SUBJECT: MASSACHUSETTS INSTITUTE OF TECHNOLOGY — AMENDMENT
RE ADMINISTRATIVE STRUCTURE (TAC NO. MB3760)

AMENDMENT TO AMENDED FACILITY OPERATING LICENSE

Amendment No. 33
License No. R-37

SAFETY EVALUATION BY THE OFFICE OF NUCLEAR REACTOR REGULATION

Fig. 7.1-1 Management Organization

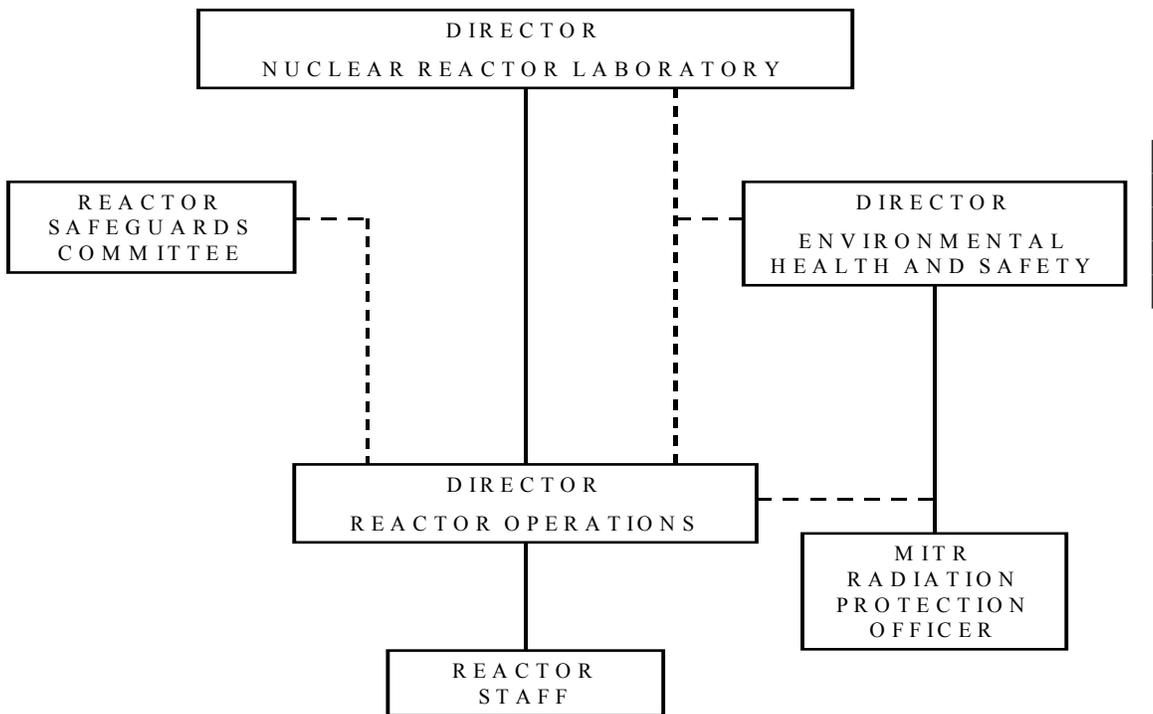
The licensee also proposes to change TS Figure 7.1.1, "Management Organization," to reflect the new reporting requirement for the MITR RPO.

The staff noted that two minor changes to proposed TS 7.1.6 were not discussed in the licensee's application, (the phrase "Director of the Nuclear Reactor Laboratory" was changed to "the Director of the Nuclear Reactor Laboratory," in the last sentence of TS 7.1.6). A typographical error was also corrected on Figure 7.1-1, "Management Organization," and TS 7.1.5, "Reactor Safeguard Committee," was changed to "Reactor Safeguards Committee." The project manager confirmed these changes with the Director of the MIT Nuclear Reactor Laboratory during telephone conversations on April 23, 2002. These changes are acceptable to the staff.

Because the proposed replacement of the MIT RPO by the Director of MIT Environmental Health and Safety maintains high-level MIT management oversight of the radiation protection program at the MITR, the staff concludes that the proposed changes to the TSs are acceptable.
